***Geoff Brown & Associates Ltd***

**TECHNICAL REVIEW OF WESTERN POWER'S  
PROPOSED ACCESS ARRANGEMENT FOR  
2012-2017**

**ECONOMIC REGULATION AUTHORITY**

**27 March 2012**

**Figure 5.1: Actual and Approved Total Capex AA1 and AA2 (\$ million, real 2011-12)**

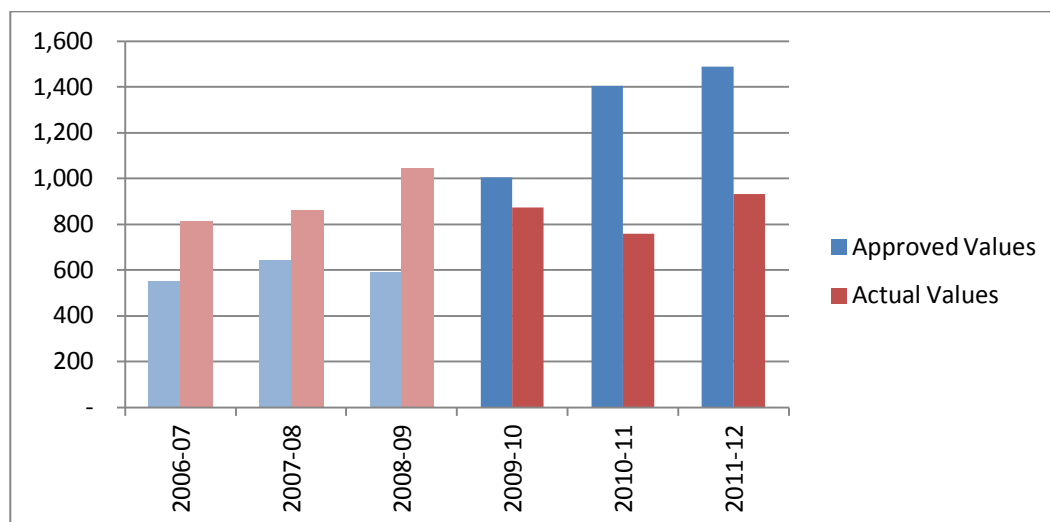
It can be seen from Figure 5.1 that the total capex in AA2 was marginally lower than the actual capex in AA1 and was substantially lower than the approved AA2 amounts. In fact, the difference between the actual and approved values for AA2 is approximately 34%.

**Figure 7.2: Forecast Network Peak Demands (MW)**

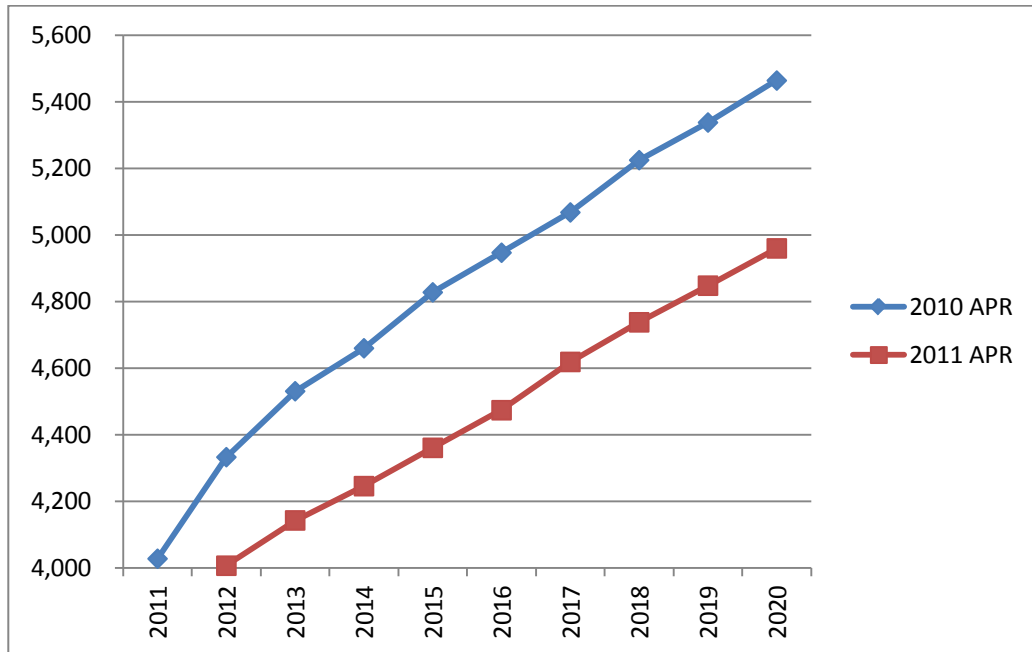
Figure 7.2 illustrates this from a different perspective. In the figure, the forecast peak demand in the 2011 APR is compared with the 2010 APR peak demand used for the

preparation of the AA3 capacity expansion capex forecast. It can be seen from Figure 7.2 that the 2011 APR demand forecast lags the 2010 APR forecast by more than three years implying that, should the 2011 forecast eventuate, the capacity expansion and voltage capex forecast for the final three years of AA3 could be deferred to AA4, and the expenditure forecast for the first two years could be spread out over the whole AA3 period.

**Figure 7.4: Impact of Proposed Adjustments on AA3 Transmission Capex Forecast (\$ million, real 2011-12)**

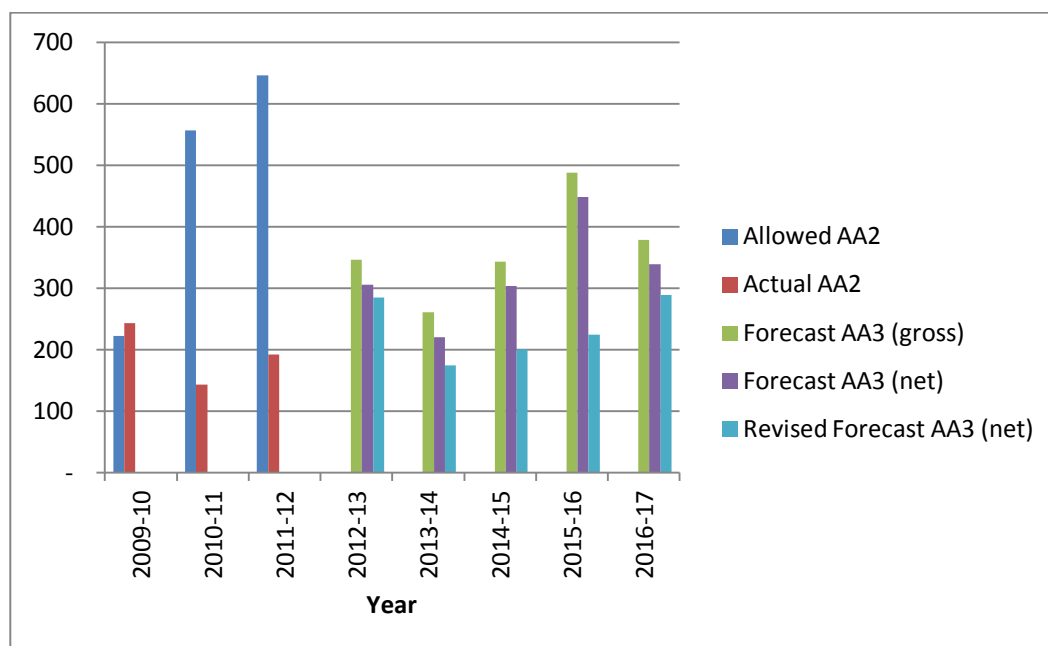
Our suggested adjustments to Western Power's AA3 transmission capex forecast are shown in Table 7.11. These adjustments do not include changes to the MWEP budget but do include our expected impact of the reduced 2011 APR peck demand forecast on Western Power's transmission opex requirements. The impact of these proposed adjustments is shown graphically in Figure 7.4.

**Figure 8.6: Impact of Proposed Adjustments on AA3 Distribution Capex Forecast (\$ million, real 2011-12)**

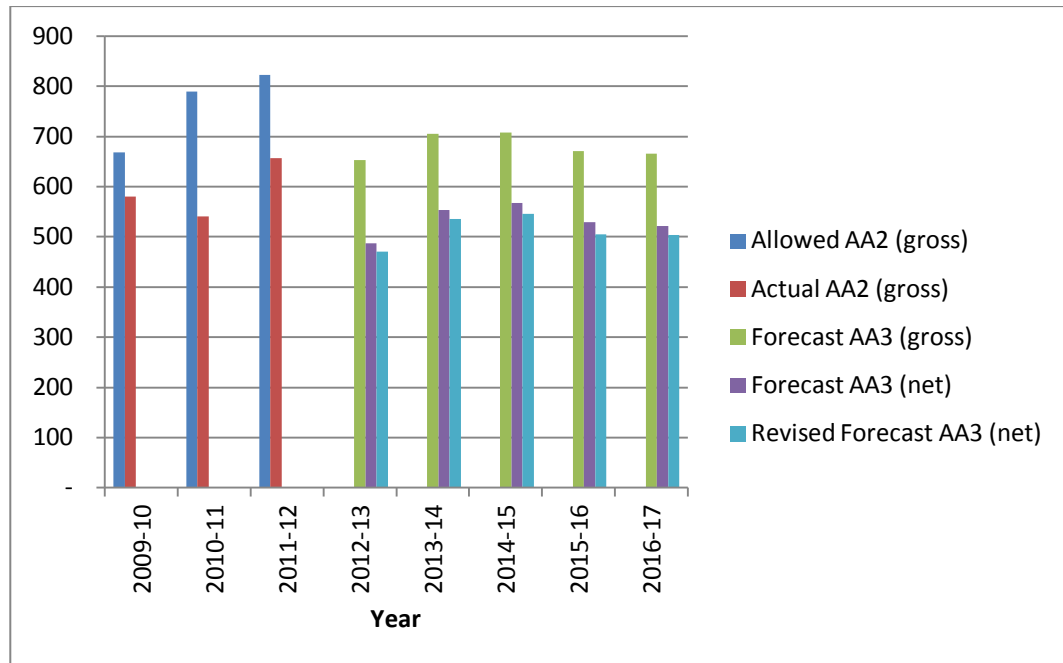
Our suggested adjustments to Western Power's AA3 distribution capex forecast are shown in Table 8.15. The impact of these proposed adjustments is shown graphically in Figure 8.6.

**Figure B2.1: 2011 Daily Maximum Peak Demands. East Perth Load Area**

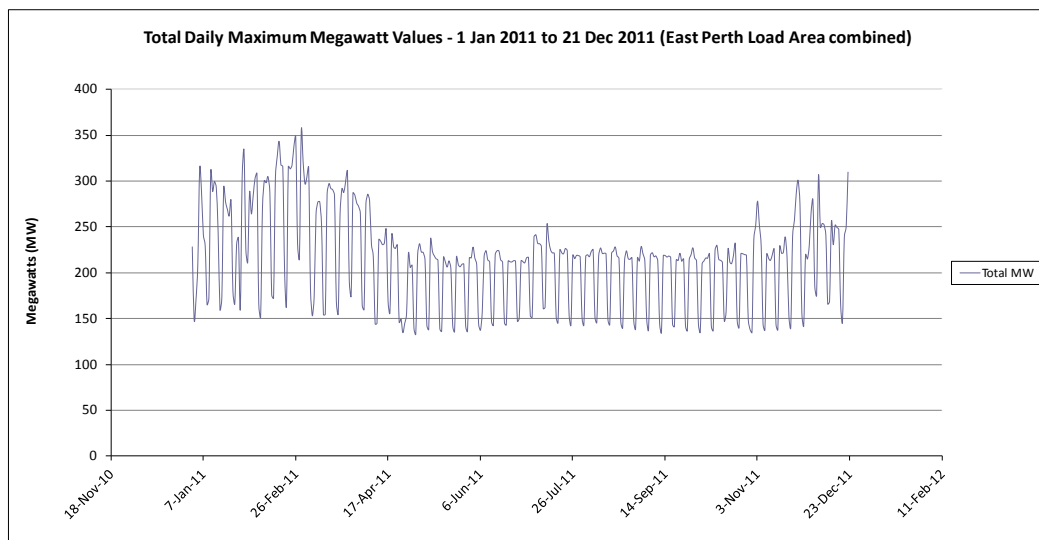
Ignoring the potential decommissioning of Forrest Avenue substation, Western Power's AA3 capex forecast involves installing 344 MVA of new transformer capacity (including the new substation and the additional Cook St transformer) in an area where the peak demand growth was project to increase by only 59 MW<sup>79</sup>. Furthermore, the 2011 actual peak demand in the CBD/East Perth area was in the order of 350 MW, as evidenced by Figure B2.1, which shows the daily maximum demand figures in the East Perth /CBD load during 2011. The figure also indicates a seven month window between April and November, when the CBD peak demand was no higher than 250 MW. We accept that issues other than actual and forecast peak demand, such as transfer constraints and the requirement to still meet the security criteria in the Technical Rules for the duration of any asset replacement project need to be considered when preparing a CBD network development plan. However the fact that actual loads are much lower than assumed by Western Power, and the existence of a seven month window where network peak demand reduces by approximately 100 MW, at the very least raises a need for a detailed development plan to support the argument that the capex forecast by Western Power is consistent with a least cost development program. This is notwithstanding the fact that, given that the new substation is not required until 2016-17, detailed planning and business case preparation for the project has still to commence.
